Concord Repatriation Hospital Redevelopment (Stage 1) Modification 7

Changes to landscaping, ESD requirements and parking
State Significant Development Modification Assessment
(SSD-9036-Mod-7)

April 2022

Published by the NSW Department of Planning and Environment

Figure 3 | At-grade carpark trees for removal highlighted in yellow and proposed replacement trees shown in green. (Source: Applicant's landscape plans)

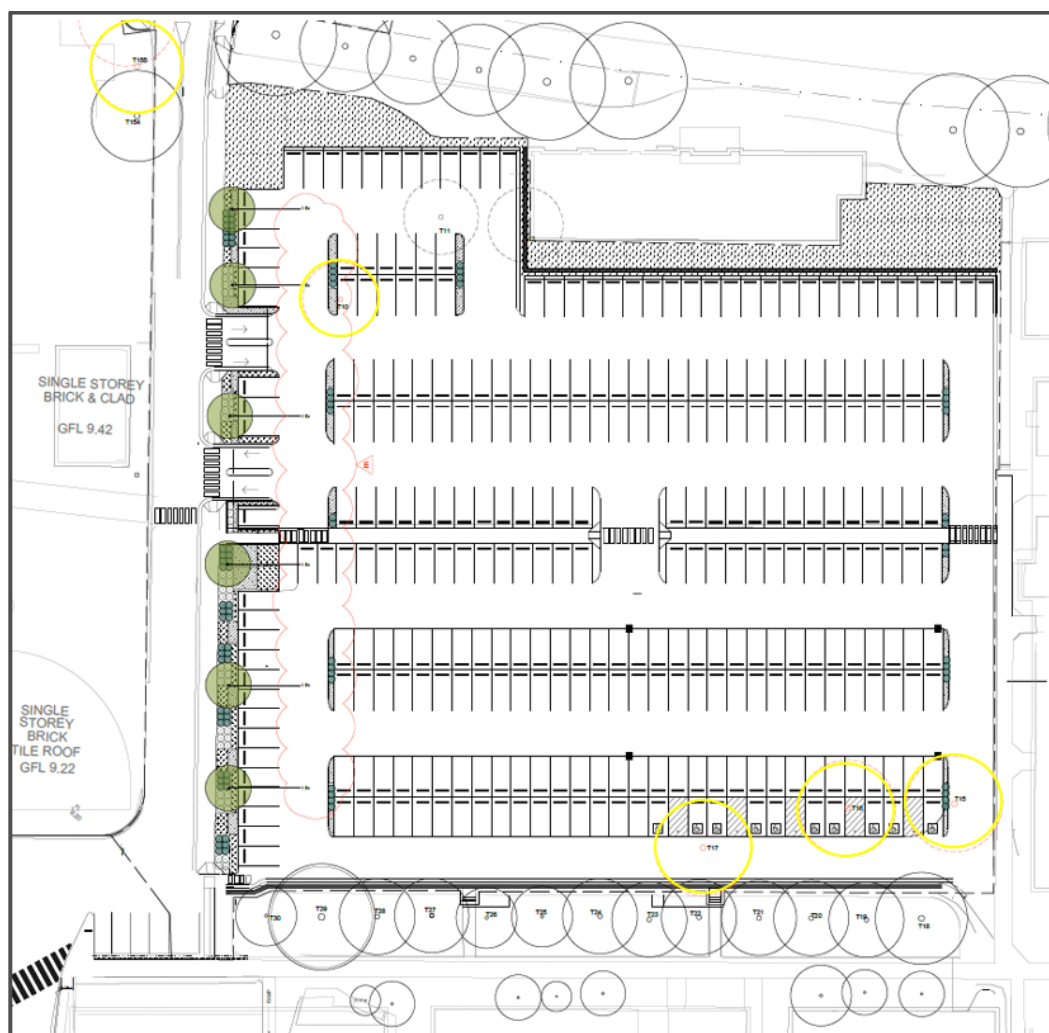
The proposal seeks the removal of 10 additional trees (tree no. 10, 15, 16, 17, 150, 155, 156, 162, 163 and 164) in the public domain areas surrounding the MSCP and temporary at-grade parking areas. This proposed tree removal has resulted from design changes, including the amendment of carpark building footprint to facilitate appropriate pedestrian access and the realignment of the MSCP access road.

The loss of these trees will be offset by the planting of 12 locally native replacement trees and additional groundcover planting, secured via the amendment of existing condition D26. The changes to tree removal and planting are shown below in **Figures 3 and 4**.

The proposed removal of 10 additional trees to facilitate the new at-grade parking area, MSCP and Hospital Road roundabout will be offset through the replanting of 12 new locally endemic trees secured via amendments to existing condition D26. The new tree emplacements will be located within the curtilage of the proposed parking areas and are of a suitably mature 75 litre pot size to ameliorate impacts to hospital campus tree canopy.

The Department notes that EESG did not raise any concern with the removal of the nominated trees from the perspective of biodiversity, given the level of land clearing that had already occurred across the hospital campus and that none of the trees were identified species of local native significance. Furthermore, EESG's requirements for replanting in terms of a greater than 1:1 replacement ratio, maturity and the selection of local native species have all been adopted by the Applicant in their revised documentation.

Figure 6 | Carpark accessibility during the delivery of the Hospital Road roundabout (Source: Applicant's response to request for information)

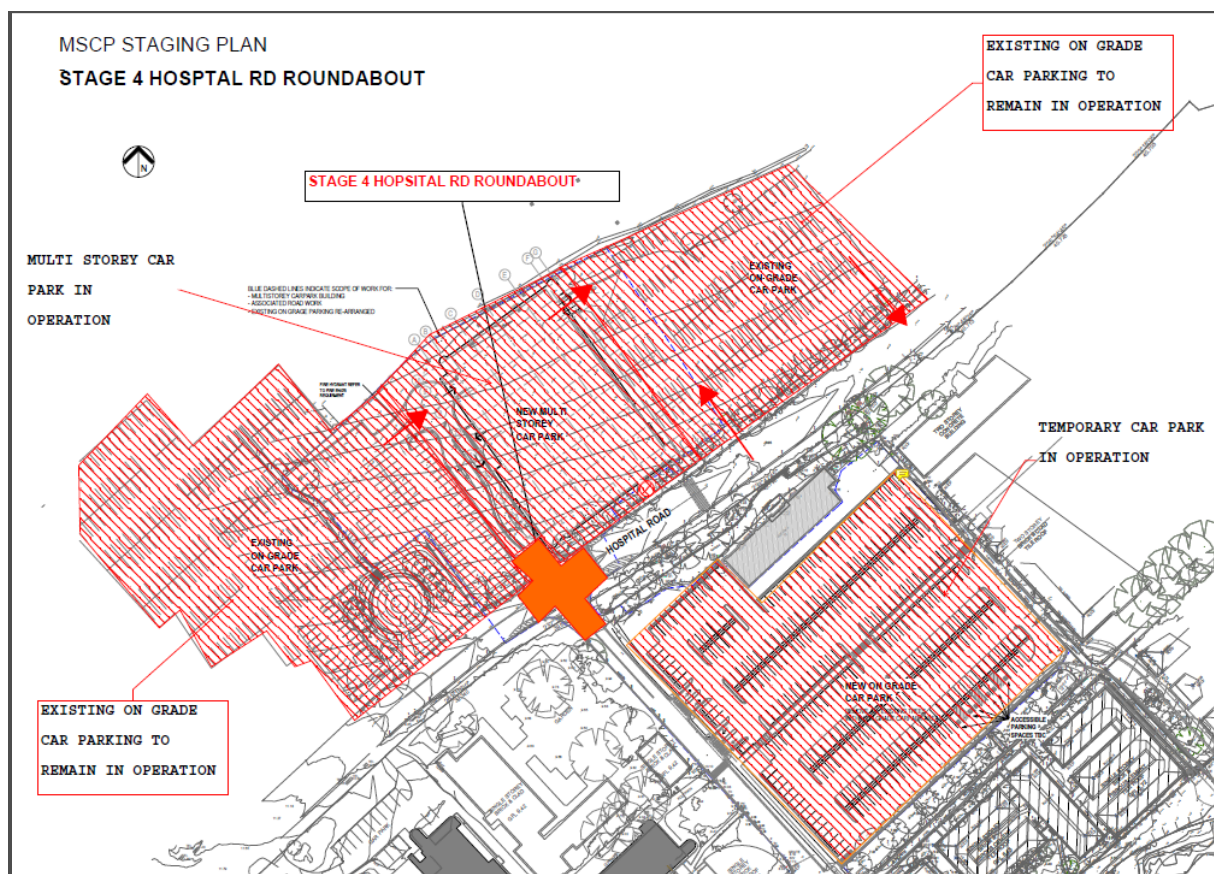
Furthermore, the delivery of the MSCP and the Hospital Road roundabout will also be managed via the creation of new carpark entrance and egress points that enable the continued use of existing parking areas during all construction phases in accordance with the diagrams shown in **Figures 5 and 6**.

The Department supports the orderly delivery of the MSCP to reduce temporary parking supply conflicts and meet the future parking demands of the under-construction Stage 1 Clinical Services Building expansion. In this regard, condition D28 of the existing consent for Stage 1 is recommended to be amended to require that no more than 300 existing car spaces are impacted at any time during construction.
